**Nebraska Public Power District**

NLS2015103  
September 8, 2015

Subject: License Amendment Request to Replace Figure with Text in Technical  
Specifications  
Cooper Nuclear Station, Docket No. 50-298, DPR-46

**License Amendment Request to Replace Figure with Text in Technical Specifications**

Figure 4.1-1 (page 1 of 1)  
Site and Exclusion Area Boundaries  
and Low Population Zone

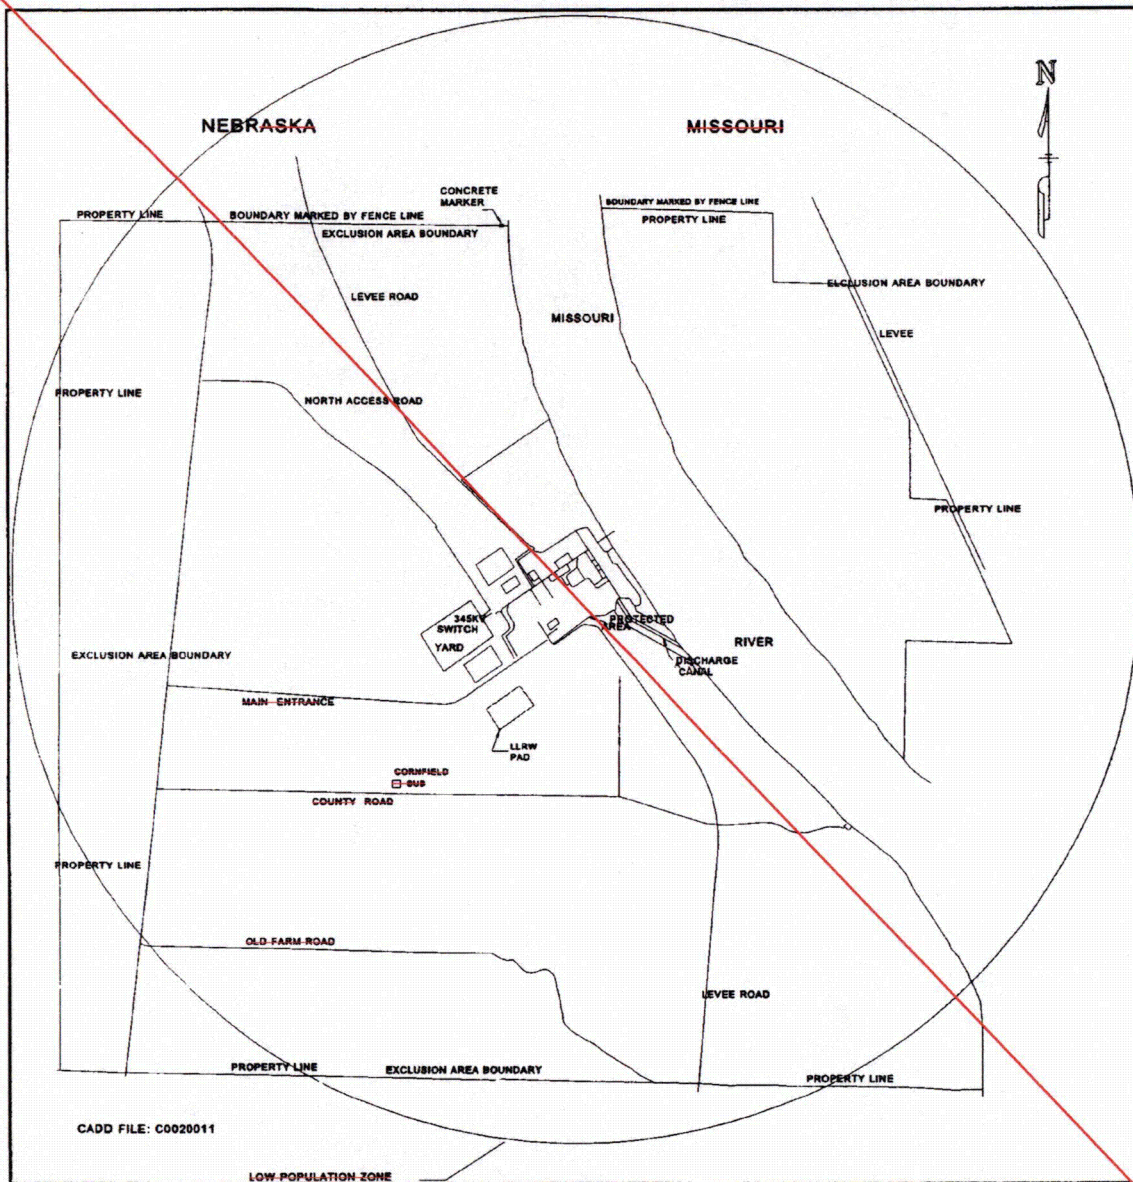
This is a request to amend the Cooper Nuclear Station Facility Operating License DPR-46 Technical Specifications (TS). The proposed amendment would modify TS to replace Figure 4.1-1, Site and Exclusion Area Boundaries and Low Population Zone, with a text description of the Site Location in Section 4.1, site location. In addition, a typographical error is being corrected in Section 1.1, Definitions.

TS Section 4.0, Design Features, Page 4.0-1, by adding a description of the site location in Section 4.1, Site Location. Delete Page 4.0-3, which contains Figure 4.1-1, Site and Exclusion Area Boundaries and Low Population Zone. This figure will remain in the Offsite Dose Assessment Manual.

~~The Site and Exclusion Area Boundaries coincide with each other and shall be as shown on Figure 4.1 1.~~

~~The low population zone is all the land within a circle with its center at the reactor and a radius of 1 mile as shown on Figure 4.1 1.~~

The station site is located in Nemaha County, Nebraska, on the west bank of the Missouri River, at river mile 532.5. This part of the river is referred to by the Corps of Engineers as the Lower Brownville Bend. The site consists of 1,351 acres of land owned by NPPD. About 205 acres of this property is located in Atchison County, Missouri, opposite the Nebraska portion of the station site. The land which the station physically occupies is bounded by the Missouri River on the east and by privately-owned property on the north, south, and west. The boundary of the exclusion area is delineated by the property lines. The distance from the reactor center to the boundary of the low population zone is a radius of 1 mile.

The station site is located in Nemaha County, Nebraska, on the west bank of the Missouri River, at river mile 532.5. This part of the river is referred to by the Corps of Engineers as the Lower Brownville Bend. The site consists of 1,351 acres of land owned by NPPD. About 205 acres of this property is located in Atchison County, Missouri, opposite the Nebraska portion of the station site. The land which the station physically occupies is bounded by the Missouri River on the east and by privately-owned property on the north, south, and west. The boundary of the exclusion area is delineated by the property lines. The distance from the reactor center to the boundary of the low population zone is a radius of 1 mile.
